ADR RECOMMENDATION PROPOSAL

09.15.23

The proposal is to construct 7 new ground related dwelling units on this LR2 site. The neighborhood concerns from outreach center mostly on the size of the project relative to the surrounding neighborhood and on available parking.

EDG MASSING

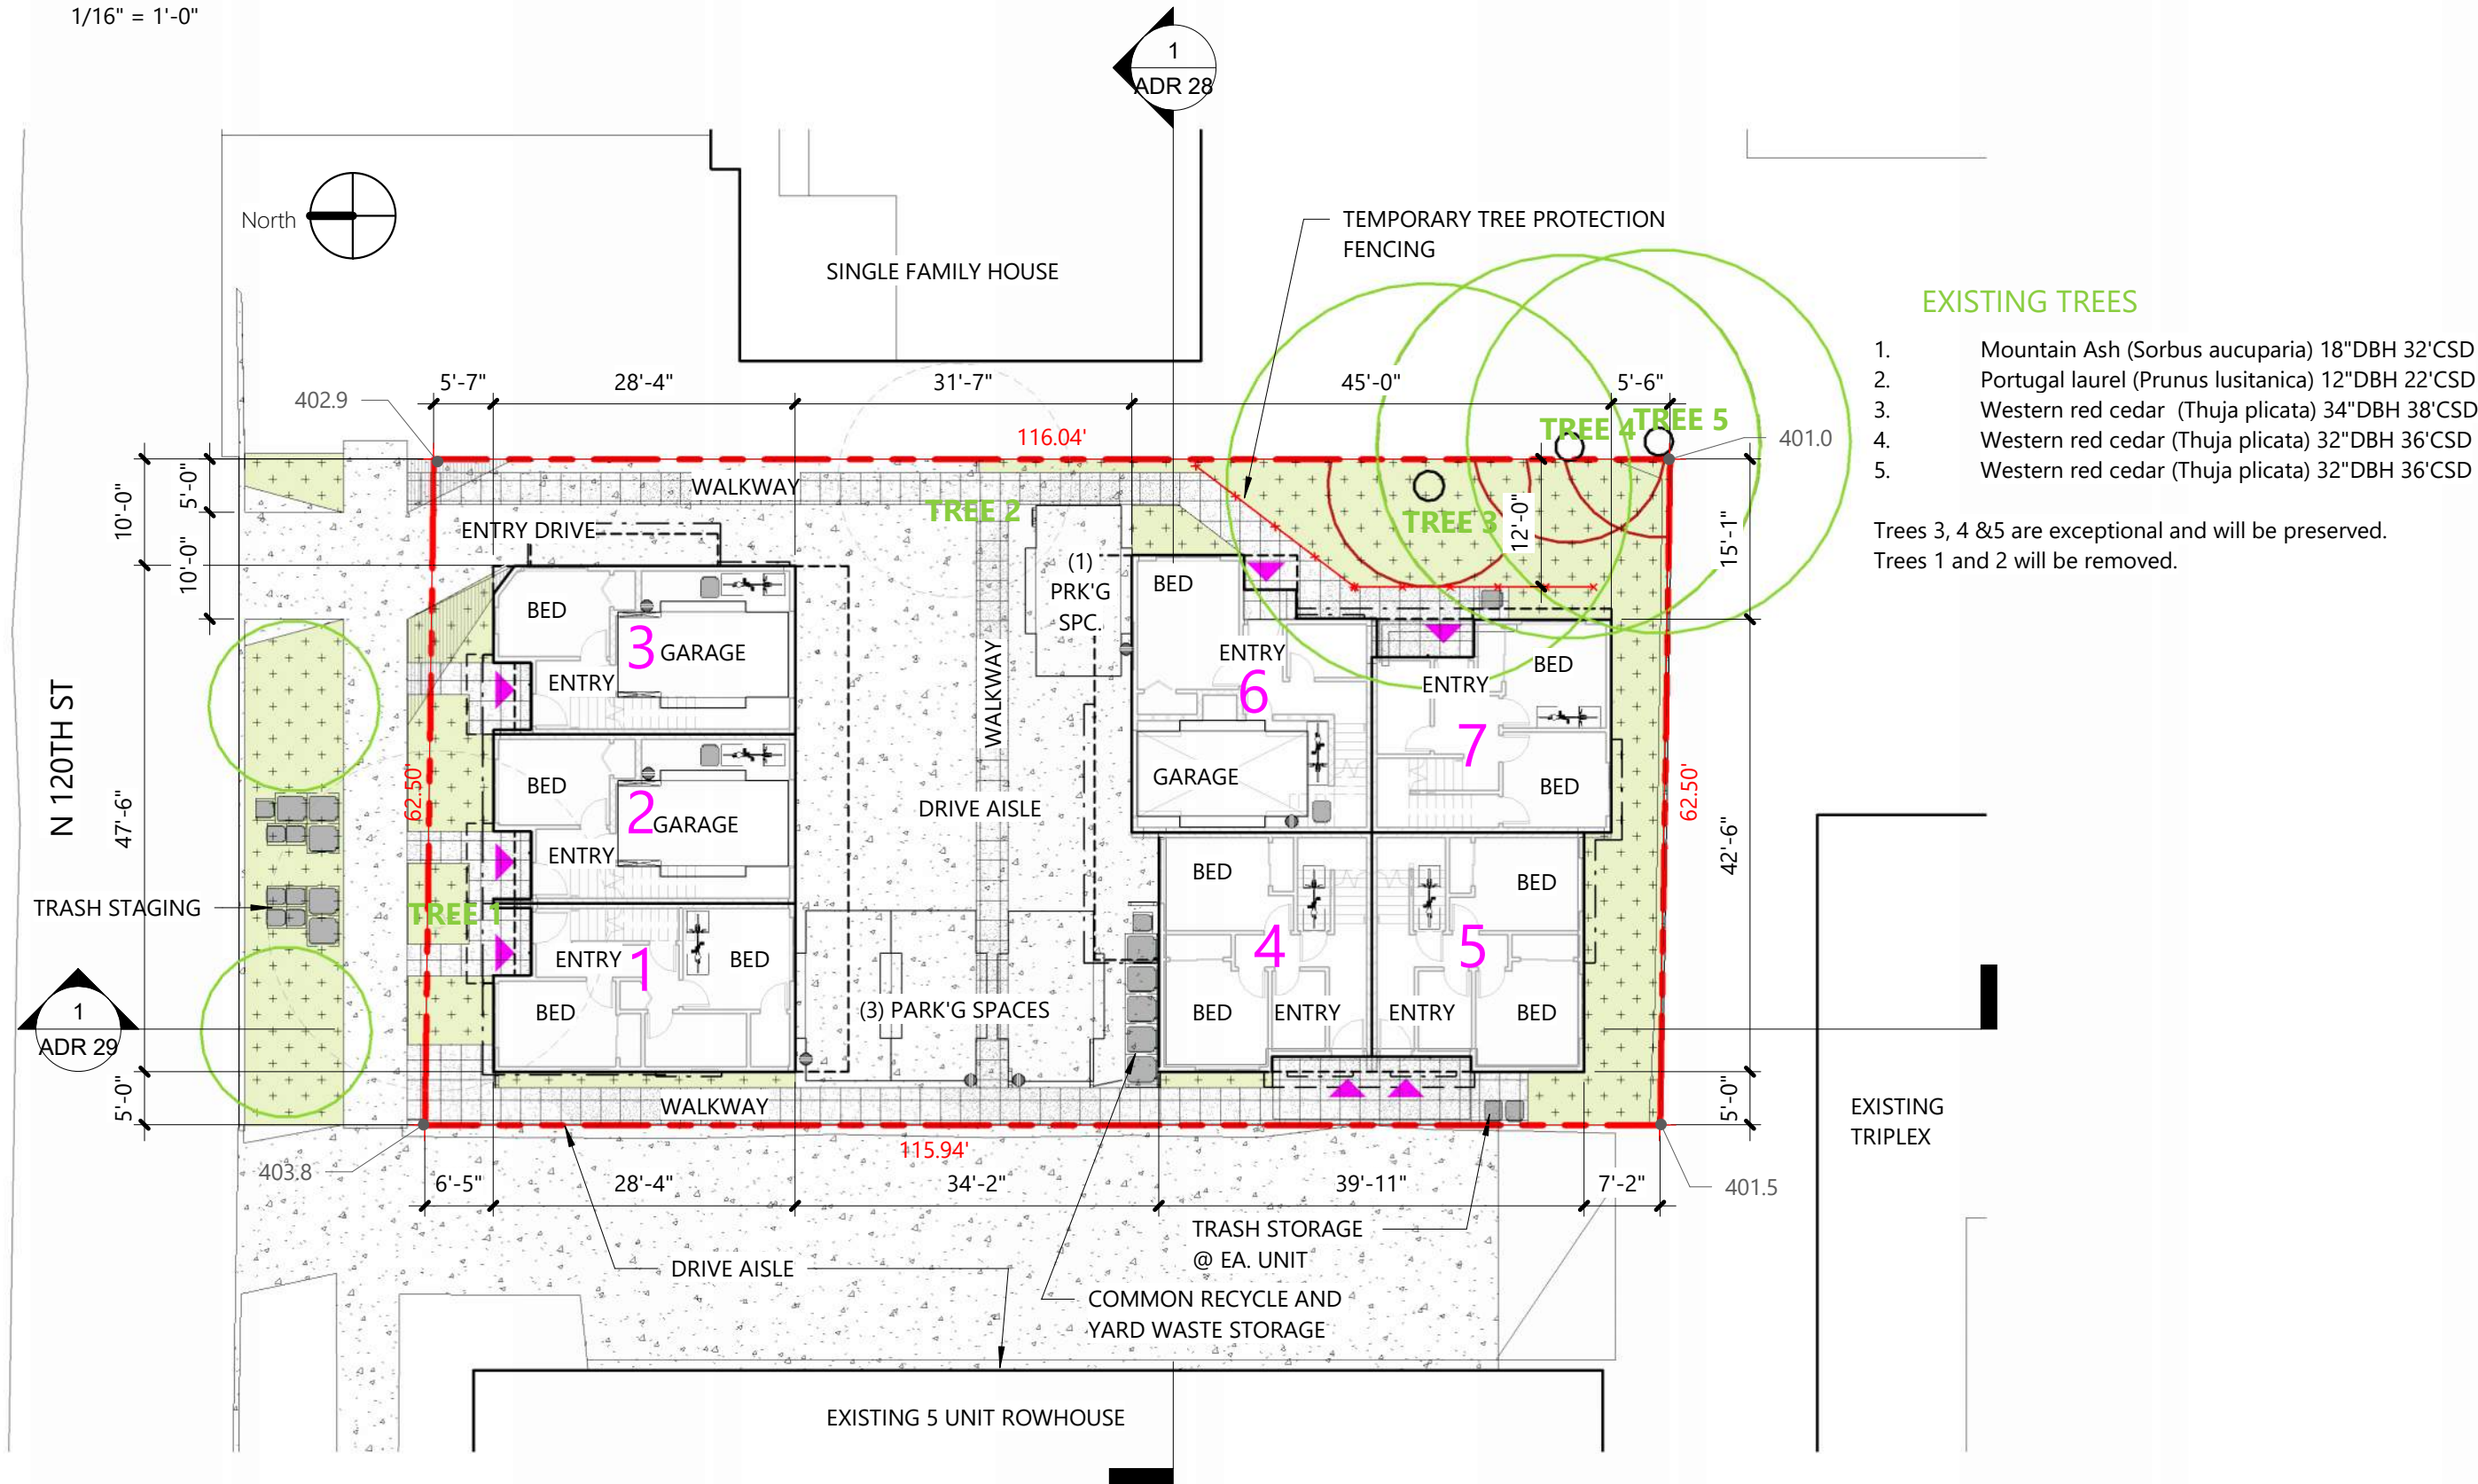
- a. Staff supports massing Option 2 in the EDG package that best addresses the massing transition along the street frontage between the LR2 zone to the west and the Neighborhood Residential to the east. The three-story volumes of the front townhomes create a relatable, residential scale along the street frontage. **CS2-C-2. Mid-Block Sites, CS2-D-1. Existing Development and Zoning, CS2-III Height, Bulk and Scale Compatibility**

- b. Staff supports the unified roof line of the three grouped units of Option 2 which simplifies the massing expression at the street edge and relates to the context of the nearby Neighborhood Residential structures. Staff also supports the similar roofline of the rear units which clearly links the two buildings when viewed in perspective. **DC2-B Architectural and Facade Composition, CS2-III Height, Bulk and Scale Compatibility**

- e. Staff notes that although the massing blocks currently show no modulation or other articulation along the street-facing frontage of Option 2, the applicant should present studies in the Recommendation package that show how relevant scale and visual interest are achieved on this visible facade. Staff recommends adding modulation at this façade by extending the expression of the recess at the front door up through the second and third level, slightly recessing the entire center unit, incorporating modulations at fenestration groupings, or similar moves. **DC2-A-2. Reducing Perceived Mass, DC2-B Architectural and Facade Composition, DC2-C-1. Visual Depth and Interest**

The owner had a strong preference for option 3 in the submittal packet based largely on the unit layouts. After email exchange with the reviewer it was decided to proceed with a compromise solution which provides a 3 unit rowhouse building similar to option 2 on the street frontage while retaining the configuration for the back building that is preferred by the owner. The applicant believes that this will provide staff with the majority of advantages that were ascribed to option 2 while respecting the owner's interest in providing the most marketable units.

The project uses the 3 unit rowhouse preferred by staff with the unified roof line. The roof massing of the rear building has been configured to relate to that of the front building as a combination of shed roof eaves and roof decks. While the rear building necessarily has a different massing due to the shape of the floor plate and related plans, the architectural expression is consistent.

Modulation has been added on the street façade including recessed entries.
